COMMISSION DELEGATED REGULATION (EU) 2023/2048

of 4 July 2023

correcting Delegated Regulations (EU) No 626/2011, (EU) 2019/2015, (EU) 2019/2016 and (EU) 2019/2018 with regard to energy labelling requirements of air conditioners, light sources, refrigerating appliances, and refrigerating appliances with a direct sales function

(1) replace the image in section 4.1 by the following image:

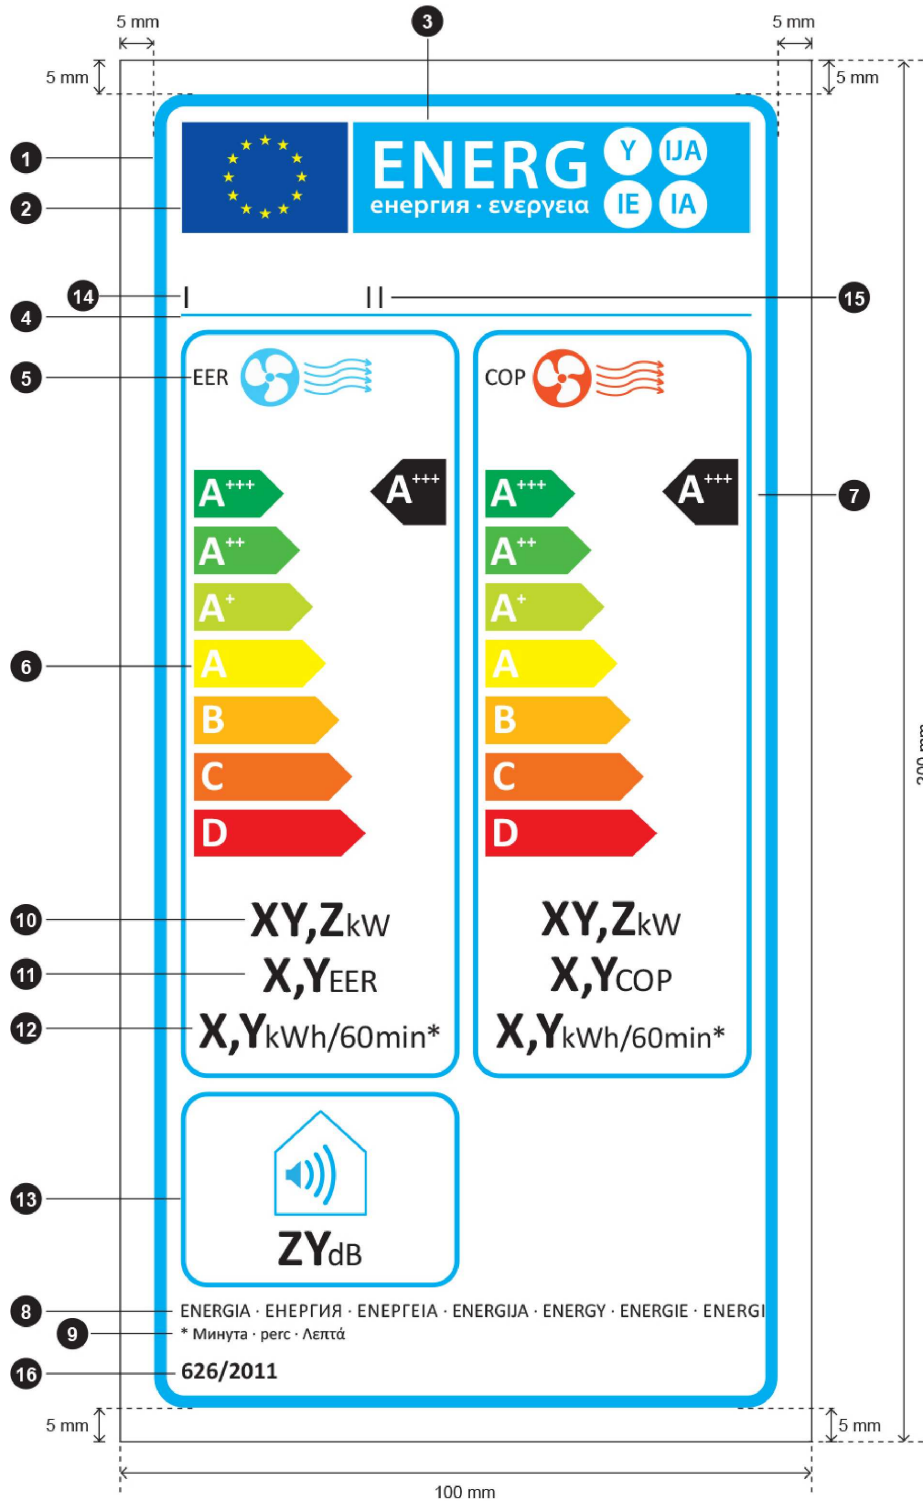
(5) in Annex III, the images should be amended as follows:
